CITY OF SAINT LOUIS

ADDENDUM NO. 3

**FOREST PARK PARKWAY
OVER METROLINK BRIDGE REPLACEMENT**

DATE: **8/9/2016**
LETTING NUMBER: **8615**

DWG. NO: S-1

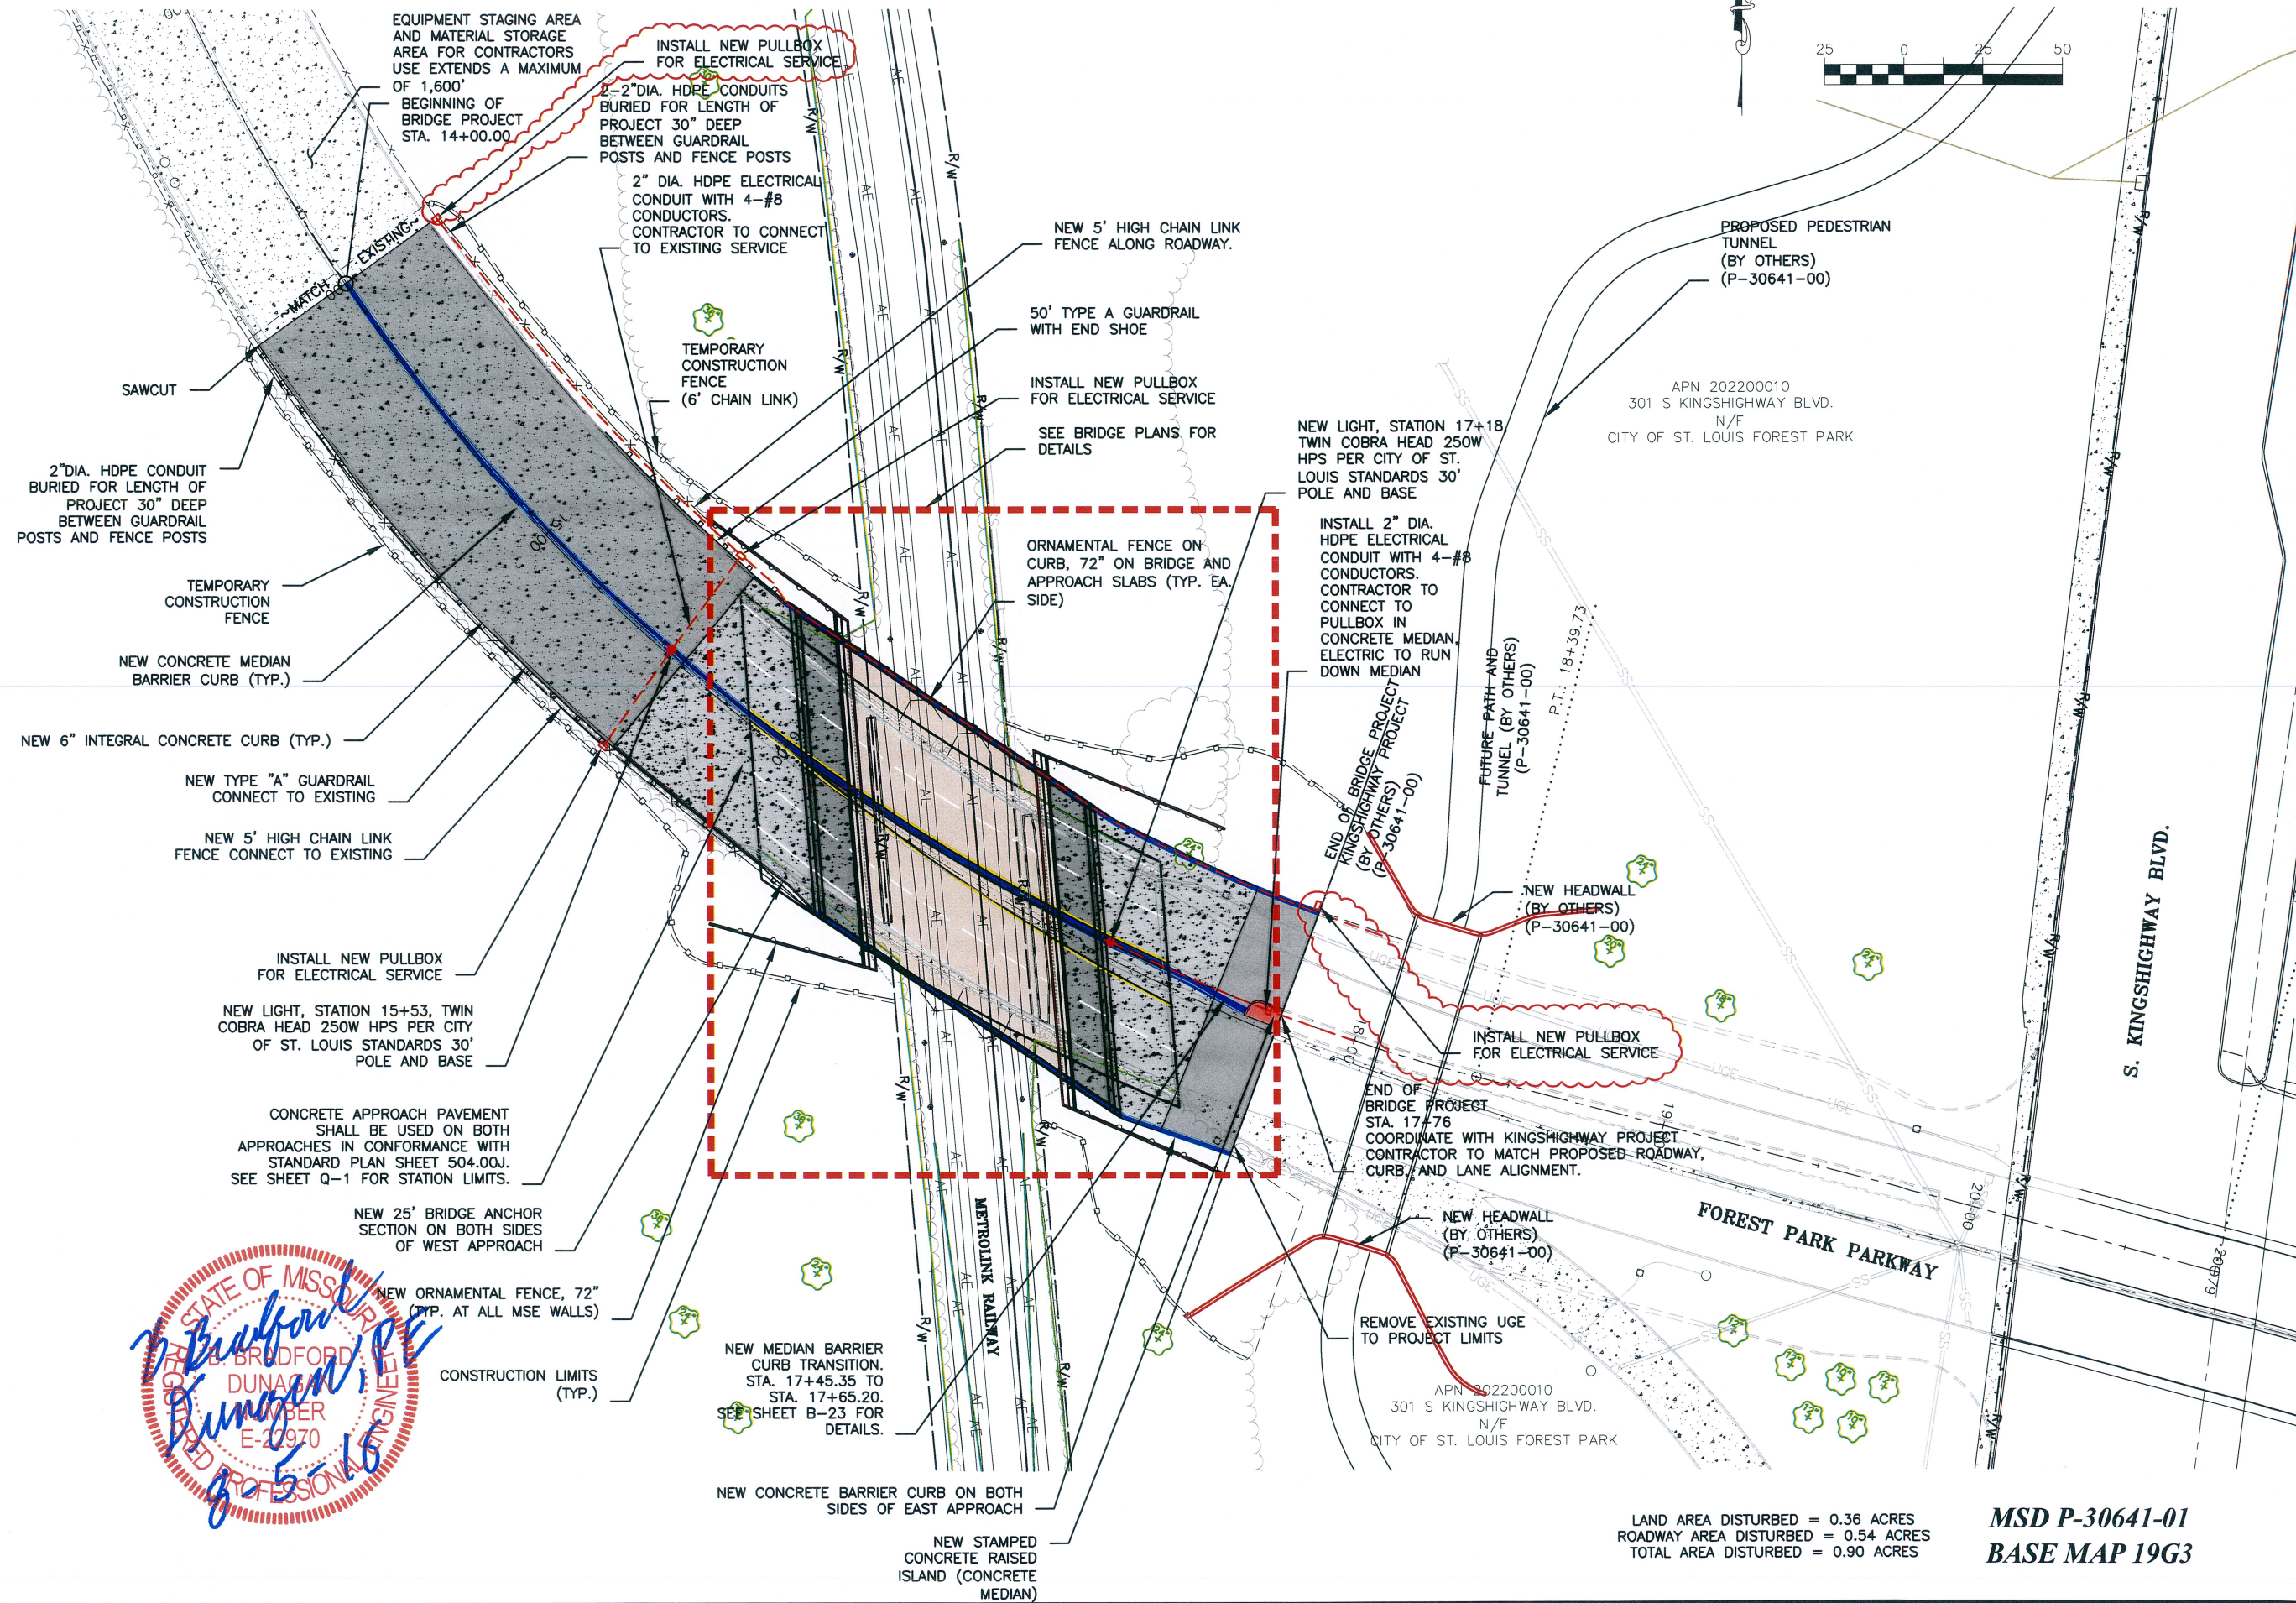
Revise Sheet S-1 to show the installation of additional lighting pullboxes at Station 14+00 left and Station 17+76 left.

DATE	REVISION	APPD. BY
8/5/16	ADDITION OF PULLBOXES	M.J.F. B.B.D.
